**MASTER SPECIAL USE  
PERMIT AND PERMIT TO  
CONSTRUCT POWER LINE  
REPLACEMENT PROJECTS**

**EIR/EIS**

*Comment Letters Received*

## Index of Commenters on the Draft EIR/EIS

**Installation of portion of new pole at SDG&E’s Crestwood Substation where MSUP work is proposed:**

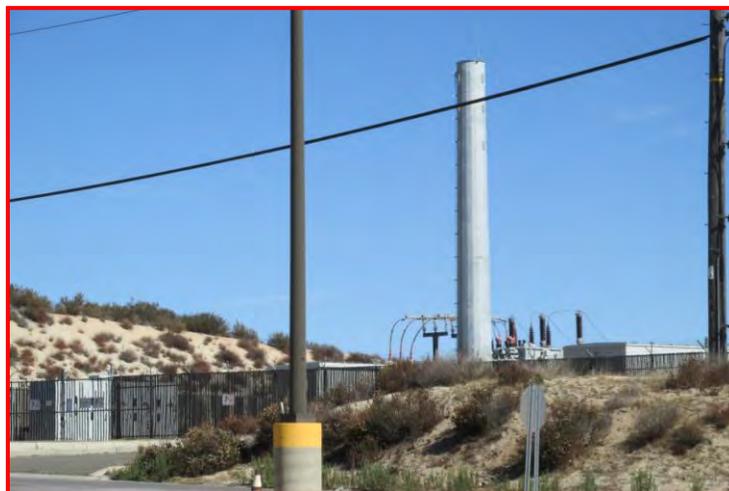
- The photograph below (Tisdale) shows the new pole that was recently installed at the Crestwood Substation located on Historic Route 80 (Old 80) adjacent to the Golden Acorn Casino located on Campo tribal lands. It appears to be advance work related to this project prior to approval. What other purpose would it serve?
